EACHTREE IND. BLVD.

TIONS SUITE 200, SUMAN

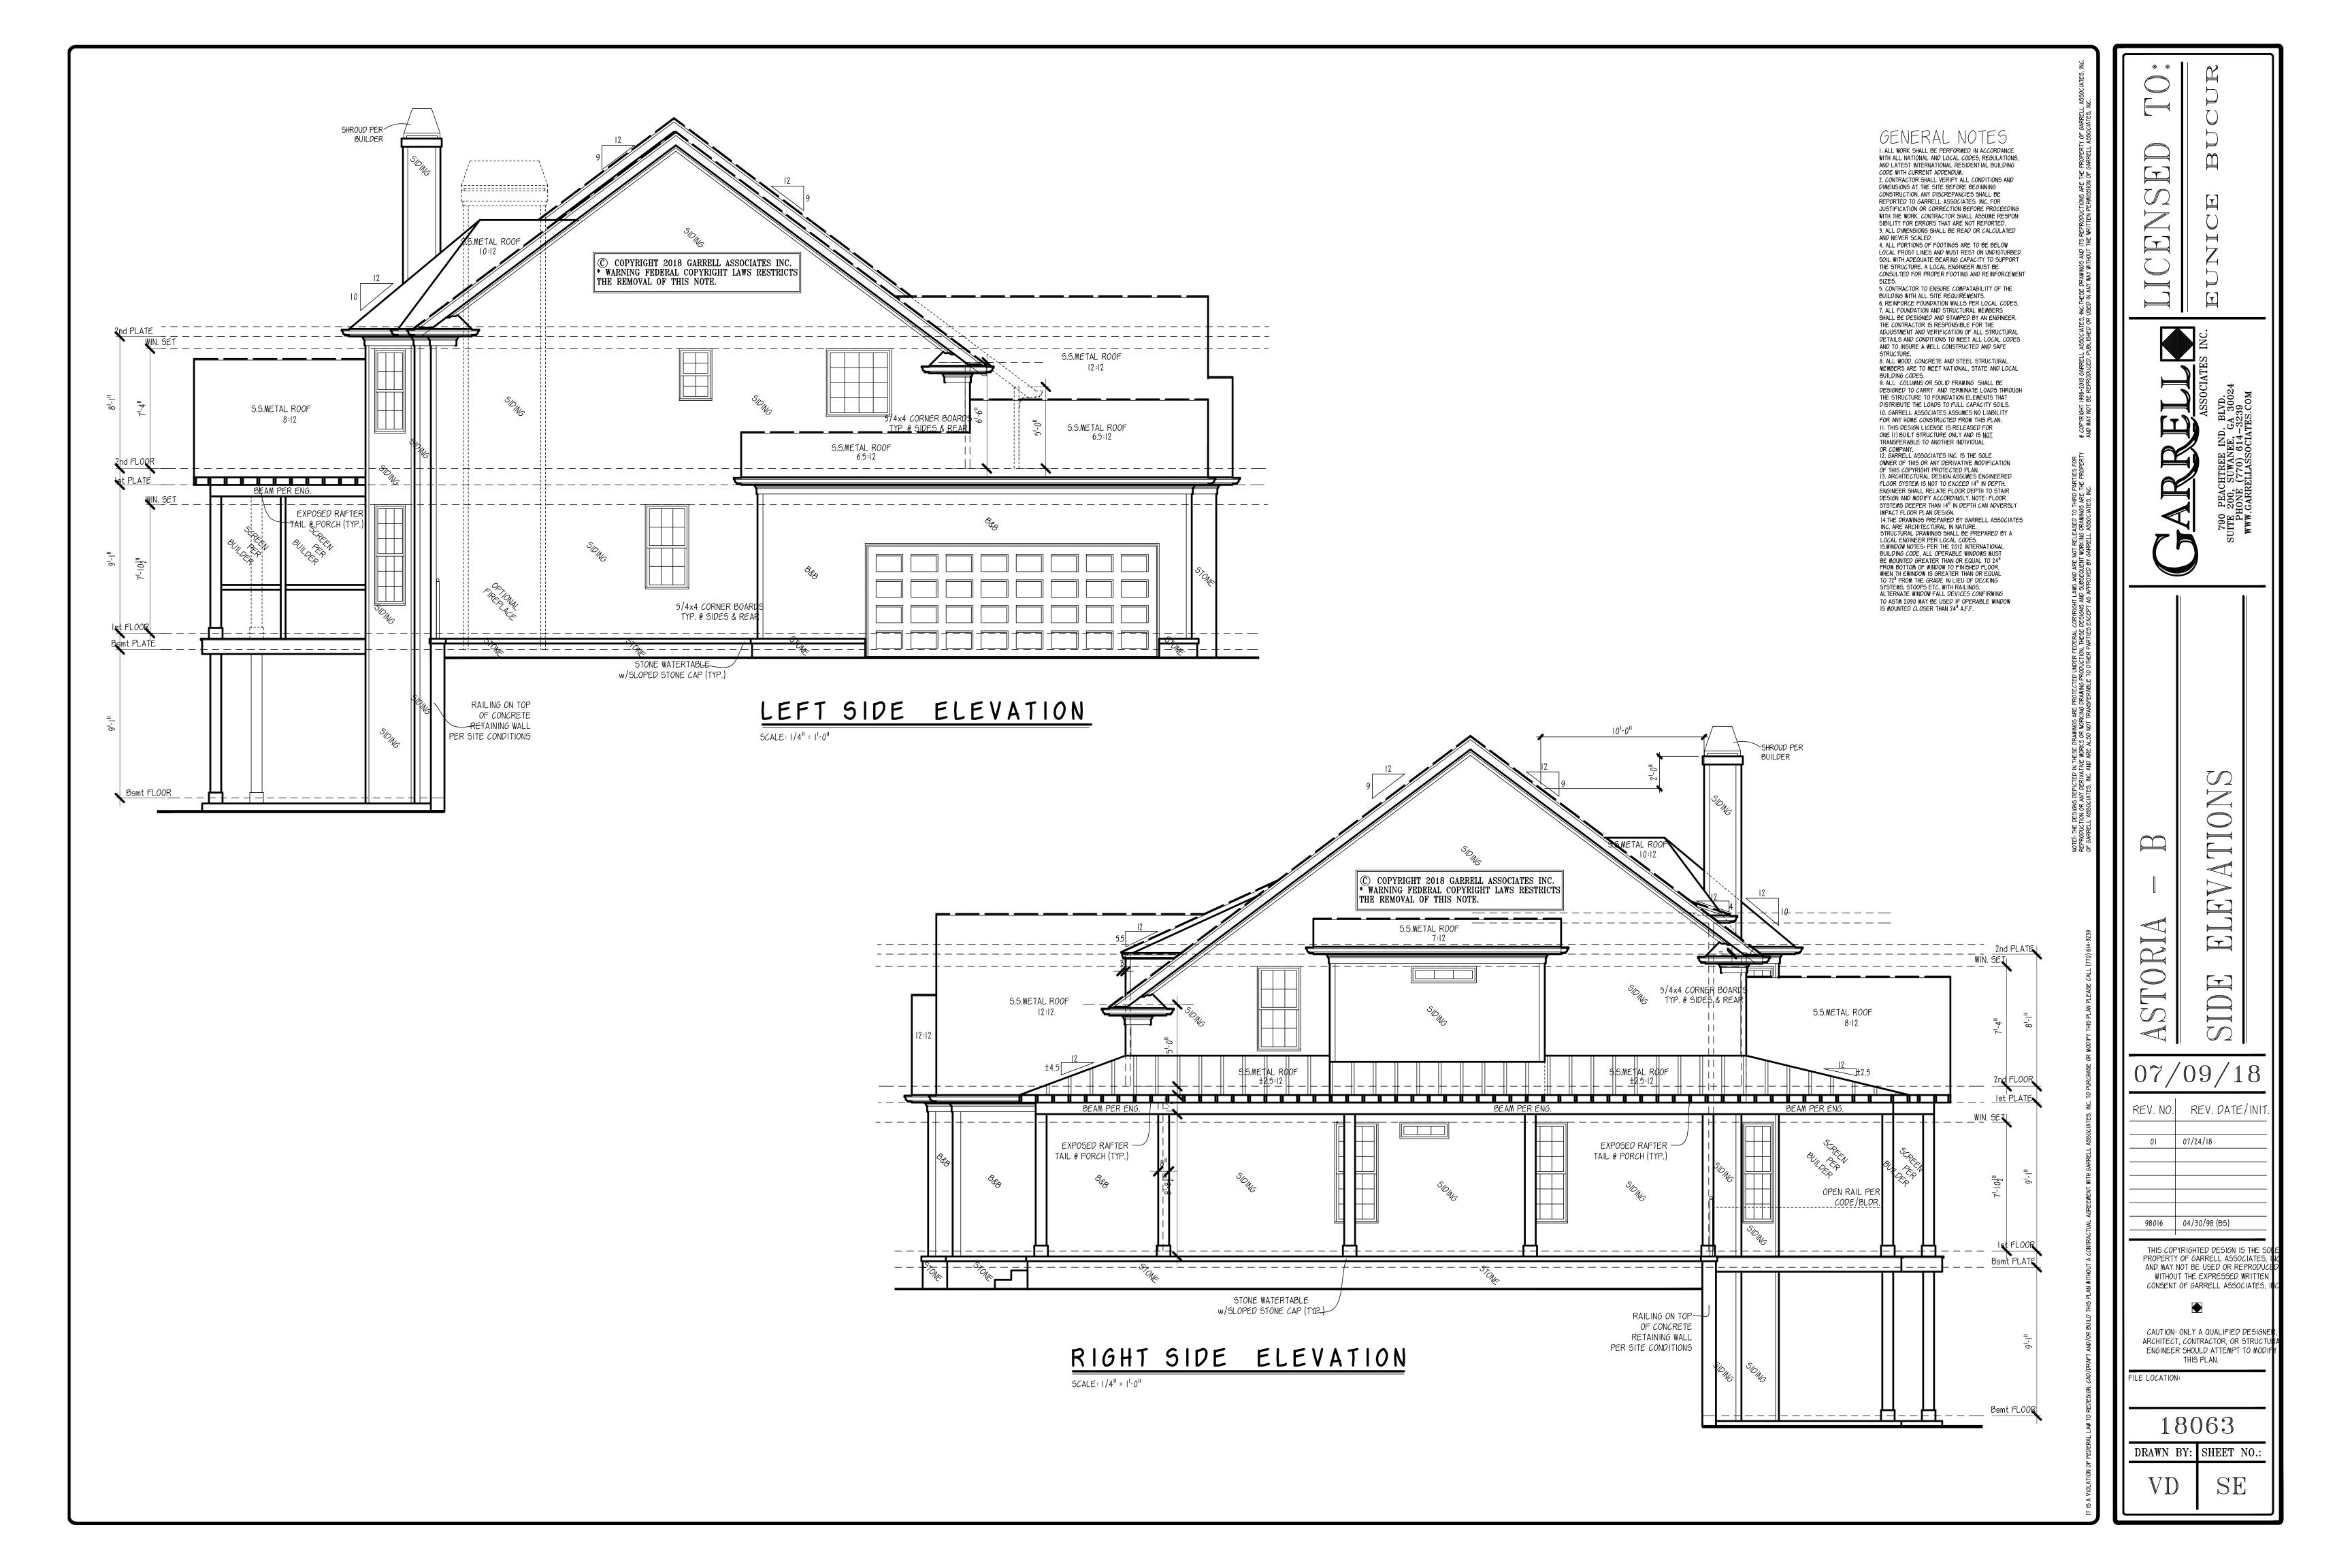
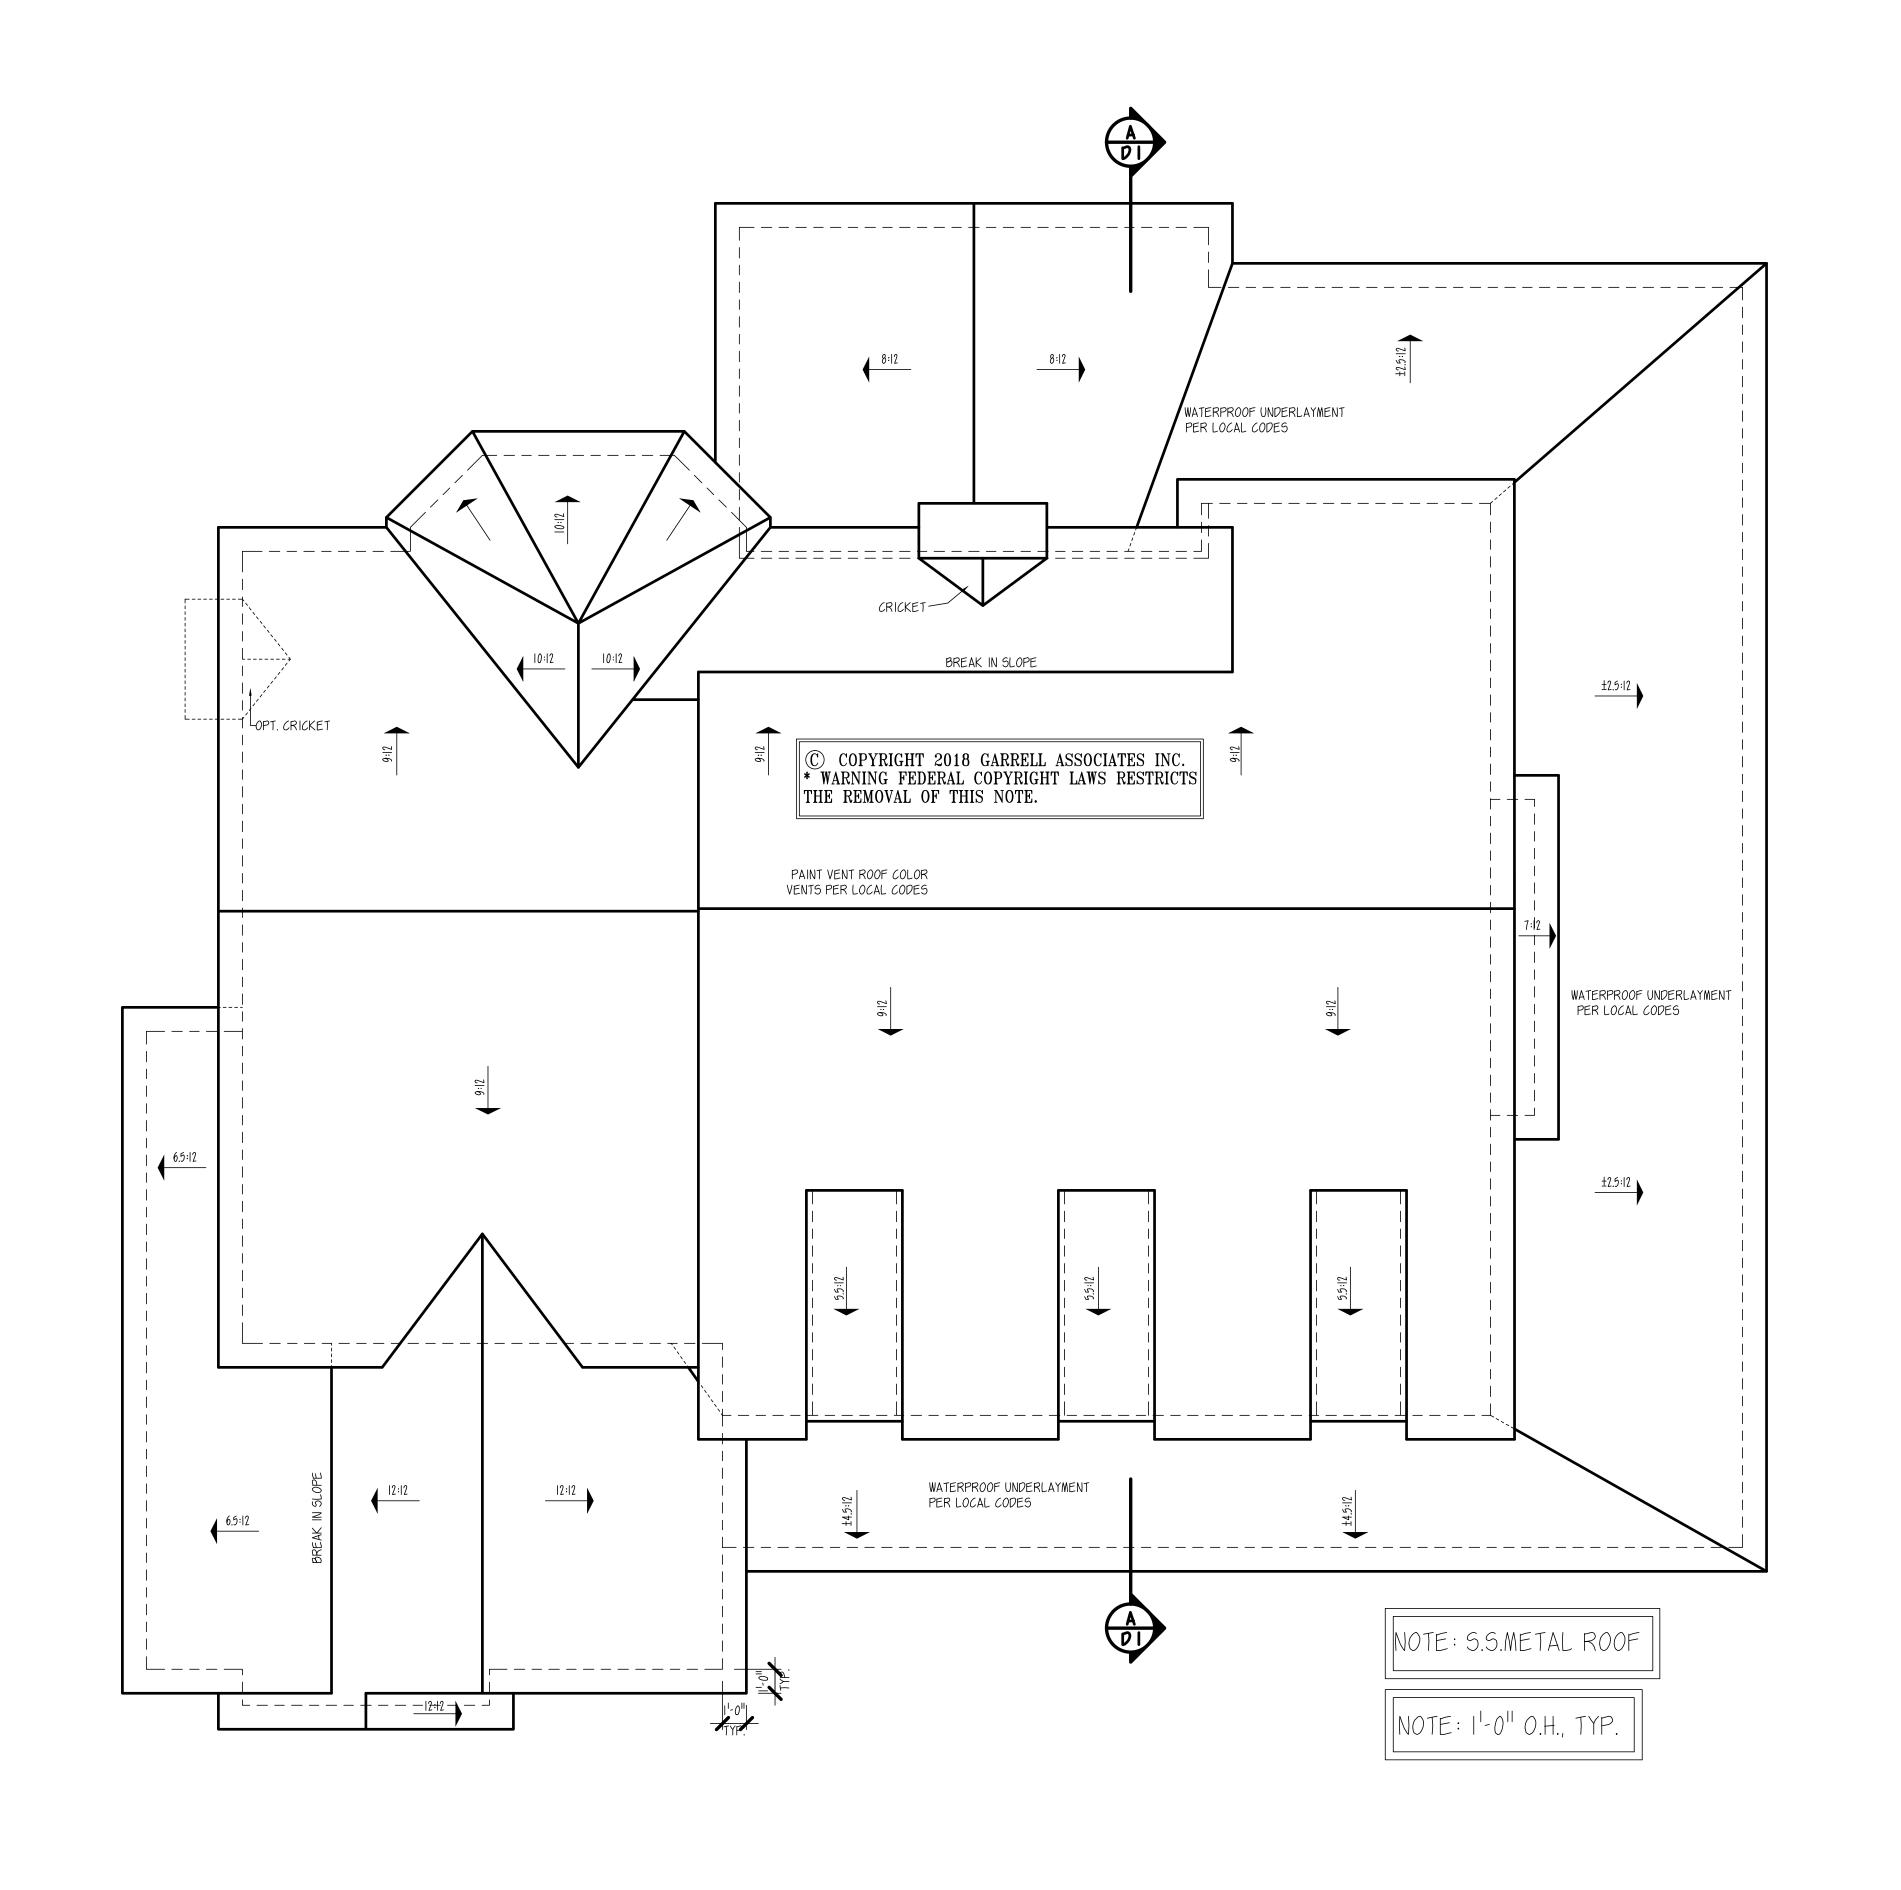
GENERAL NOTES I. ALL WORK SHALL BE PERFORMED IN ACCORDANCE WITH ALL NATIONAL AND LOCAL CODES, REGULATIONS, AND LATEST INTERNATIONAL RESIDENTIAL BUILDING CODE WITH CURRENT ADDENDUM.

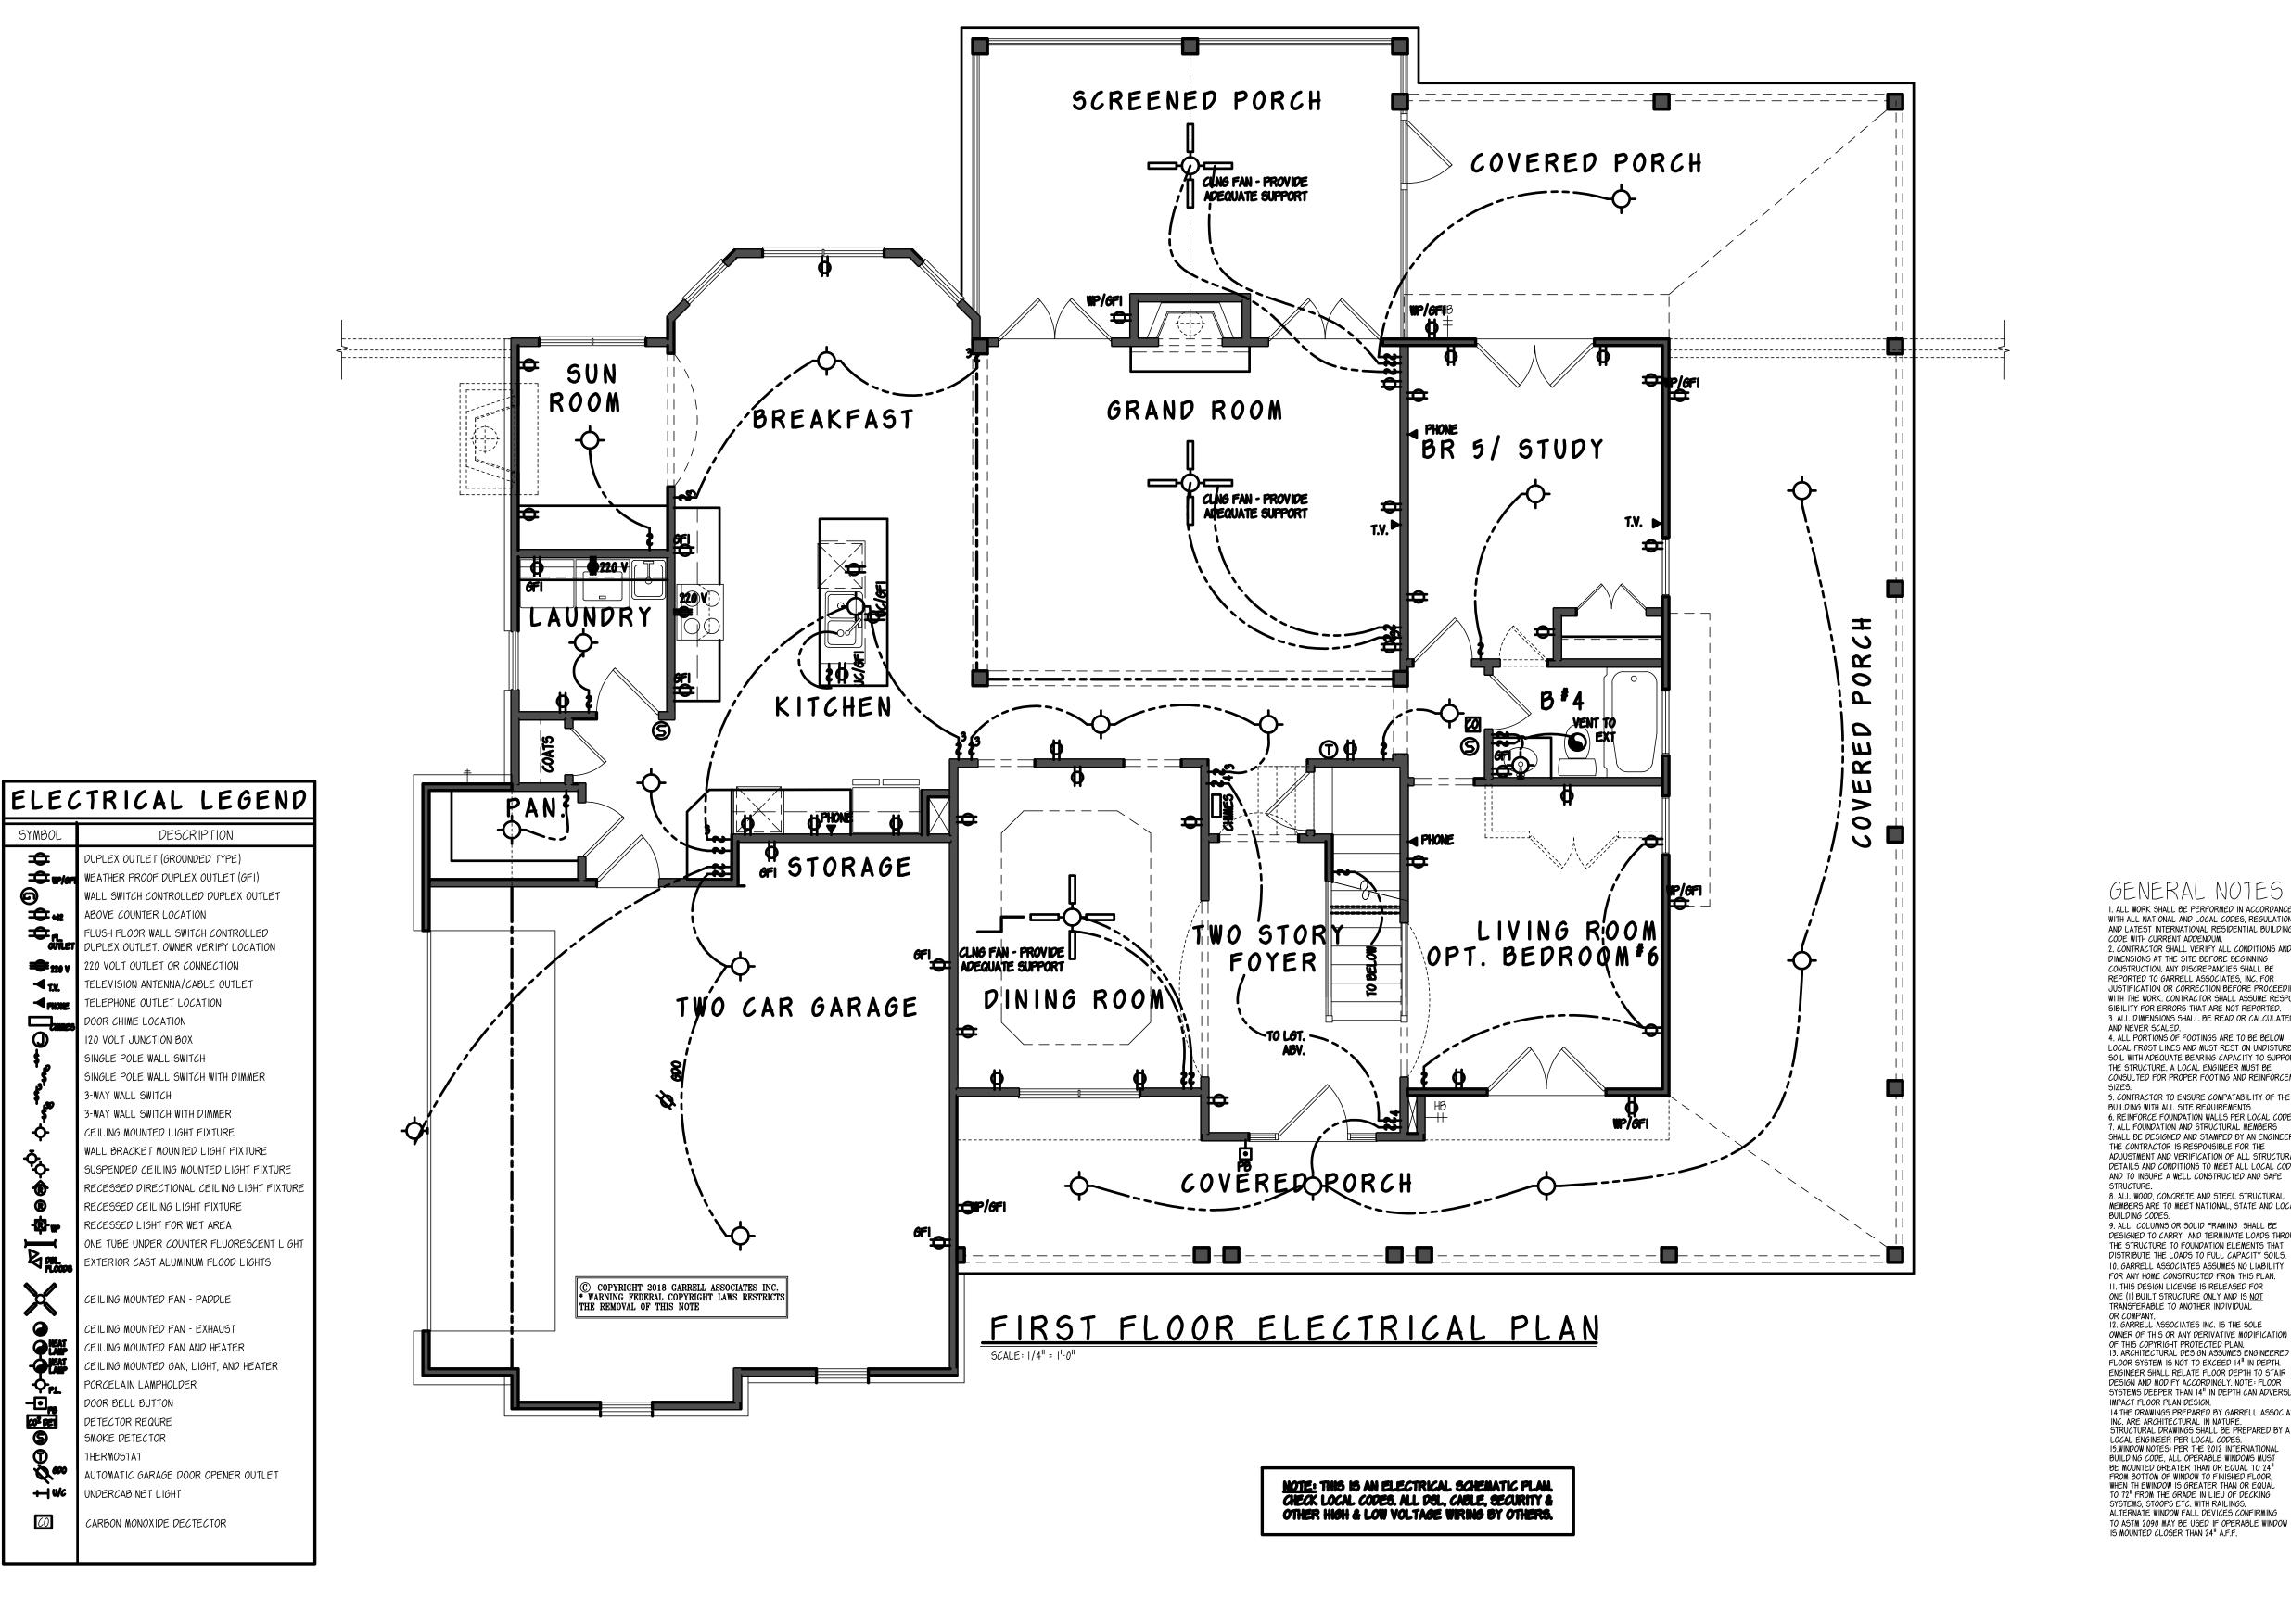
GENERAL NOTES I. ALL WORK SHALL BE PERFORMED IN ACCORDANCE WITH ALL NATIONAL AND LOCAL CODES, REGULATIONS, AND LATEST INTERNATIONAL RESIDENTIAL BUILDING CODE WITH CURRENT ADDENDUM. 2. CONTRACTOR SHALL VERIFY ALL CONDITIONS AND DIMENSIONS AT THE SITE BEFORE BEGINNING CONSTRUCTION. ANY DISCREPANCIES SHALL BE REPORTED TO GARRELL ASSOCIATES, INC. FOR JUSTIFICATION OR CORRECTION BEFORE PROCEEDING WITH THE WORK. CONTRACTOR SHALL ASSUME RESPON-SIBILITY FOR ERRORS THAT ARE NOT REPORTED. 3. ALL DIMENSIONS SHALL BE READ OR CALCULATED
